CASE COMMENT REPORT

CASE NO. UDP-S25020

CASE	UDP-S25020
PROJECT NAME	Midtown Progresso
APPLICATION TYPE	Site Plan Level II
APPROVAL LEVEL	DRC, Subject to Commission Request for Review
REQUEST	249 Multifamily Units and 1,665 Square Feet of Commercial Use
APPLICANT	Advantis MCA Flagler Triangle, LLC.
AGENT	Barbara Hall, Greenberg Traurig, P.A.
PROPERTY ADDRESS	4 NW 7 th Street
ABBREVIATED LEGAL DESCRIPTION	Progresso, Plat Book 2, Page 18
ZONING DISTRICT	Northwest Regional Activity Center – Mixed Use east (NWRAC-MUe)
LAND USE	Northwest Regional Activity Center
COMMISSION DISTRICT	2 – Steven Glassman
NEIGHBORHOOD ASSOCIATION	Progresso Village Association
SUBMITTED	August 8, 2025
COMPLETENESS ISSUED	August 19, 2025
STATE STATUTE 166.033 EXPIRATION	February 15, 2026 (180 Days)
CASE PLANNER	Jim Hetzel, Principal Planner, AICP

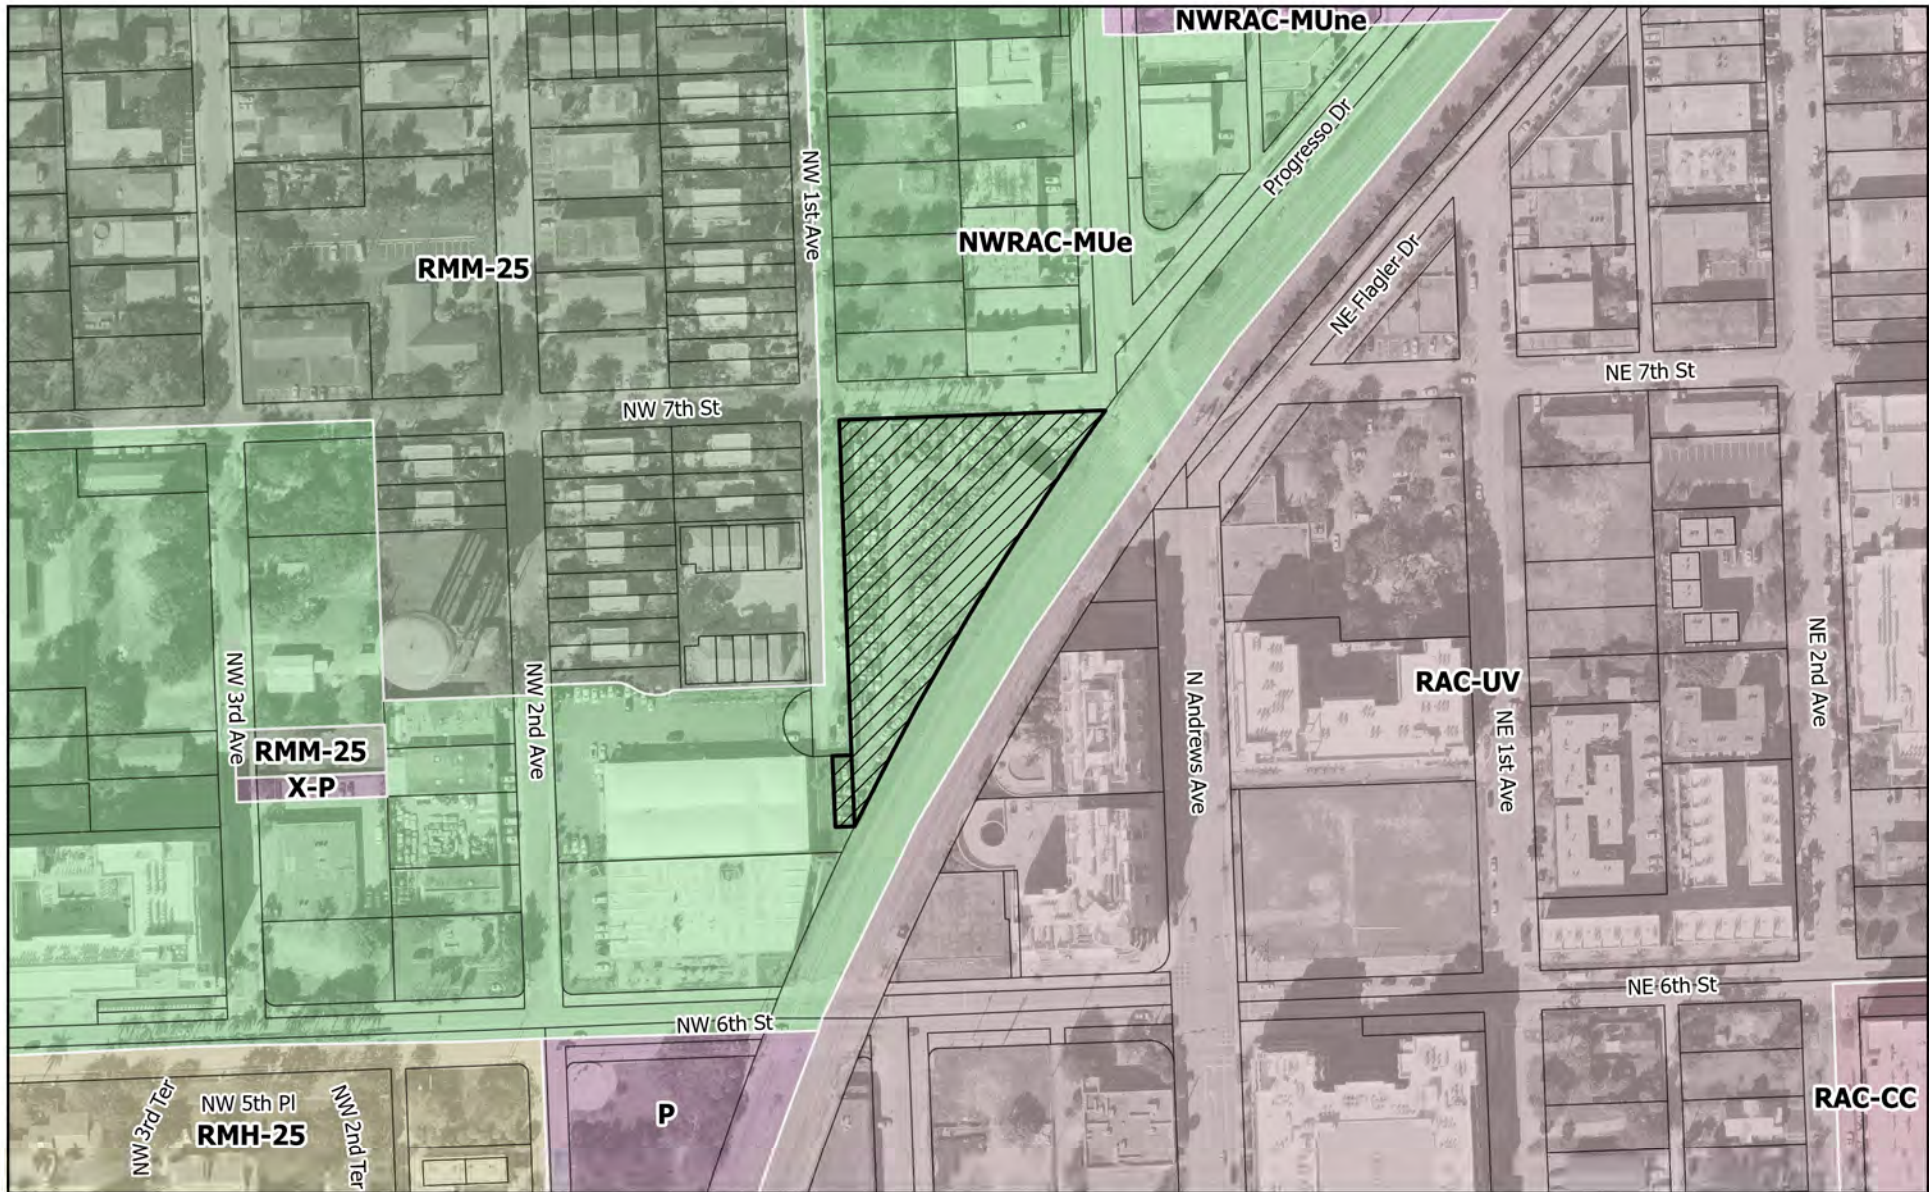
- g. B-5, the entire ground level frontage along NW 1st Avenue is inactive which does not meet the NWRAC intent;
- h. B-8, the maximum streetwall length is 150 feet unless the building design varies with significant articulation, division of the building, façade design variation, recessed build areas, etc. The project exceeds the streetwall length with 276 feet along NW 7th Avenue and 424 feet along NW 1st Avenue. Provide detailed axonometric drawings that demonstrates compliance with breaking the streetwall;

- i. B-9a, building height is 127 feet which exceeds the permitted height of 120 feet;
- j. B-9c, tower floorplate of 18,845 square feet exceeds the permitted floorplate of 12,000 square feet;

- k. B-10, a tower floorplate of 12,000 square feet requires a stepback of 30 feet, project indicates a stepback of 12-feet with encroachments for a 18,845 square feet floorplate size;

- l. B-13, tower top does not contribute to the skyline and lacks architectural treatments and elements for visually interest tower design;
 - m. B-15, provide additional high-quality building material for the lower levels;
